Drift Measurement TLV

https://www.ieee802.org/1/files/public/docs2023/60802-McCall-Time-Sync-Update-16-Jan-0123-v01.pdf

Two difficult examples

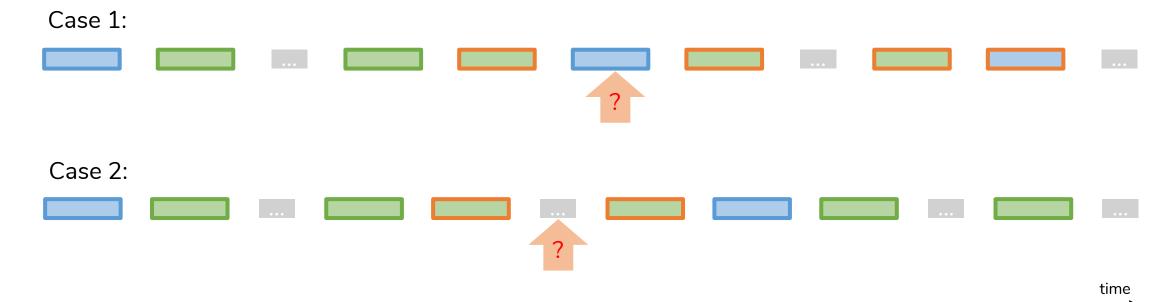
- This argument assumes a fully static network configuration and therefore a pre-determined sync-tree for all (error) cases and domains – i.e. full external port configuration!
- Changes to the GM identity or the number of hops (steps removed) is only relevant in a specific AS-Domain!
- The AS domainNumber is the only element linking Announce and Sync/FollowUp messages.
- Sync/FollowUp (w/ Drift Measurement TLV) and Announce are sent at significantly different intervals, with the Announce interval assumed to be longer.
- Sync/FollowUp (w/ Drift Measurement TLV) and Announce are tiggered by independent state machines.

- The combination of using Sync/FollowUp with Drift Measurement TLV AND Announce likely raises more handling questions than it helps an implementation.
- Use either Announce OR Sync/FollowUp with Drift Measurement TLV.
- Add this as an informative statement in ASdm.
- Do not(!) try to resolve the handling questions from using both in ASdm.
